ATTACHMENT NO. 5

TECHNICAL COMMITTEE RECOMMENDATION

TECHNICAL COMMITTEE: Bicycle Technical Committee

TOPIC: Revision of Use of Bicycle Lane Signs
Part 9 of the MUTCD

SHS figures

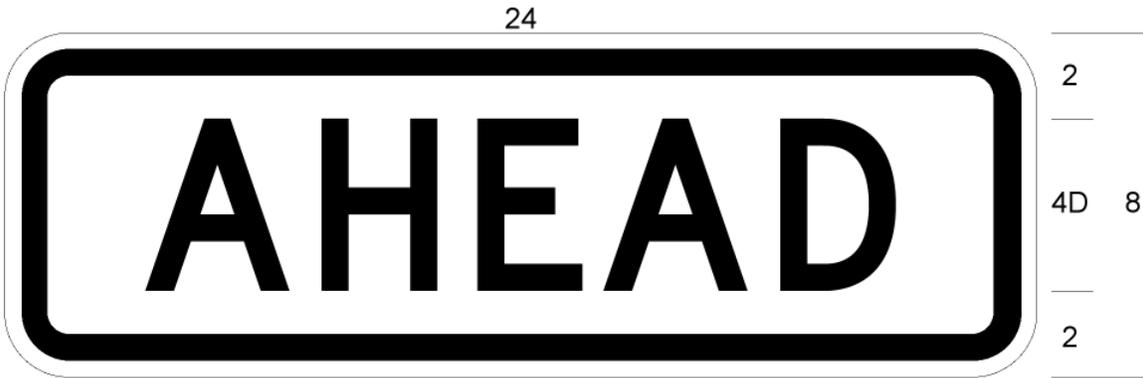
The Bicycle Technical Committee also proposes to change the minimum size of the R3-17 sign to 24" x 18" (600 mm x 450 mm), and to change the minimum size of the R3-17a and R3-17b to 24" x 8" (600 mm x 200 mm). It was the original intent of the NCUTCD Bicycle Technical Committee to establish these sizes as the minimum sizes in the 2003 MUTCD, but this was inadvertently overlooked during rulemaking. This will result in the minimum R3-17 size being consistent with the current size of the D11-1 BIKE ROUTE sign. The 24" x 18" size should provide more than adequate visibility at typical arterial traffic speeds, and can better fit in restricted locations in urban environments.

Bike Lane	R3-17	—	750600 x 600450 <u>(3024 x 2418)</u>
Bicycle Lane Supplemental Plaques	R3-17a,b	—	750600 x 300200 <u>(3024 x 128)</u>
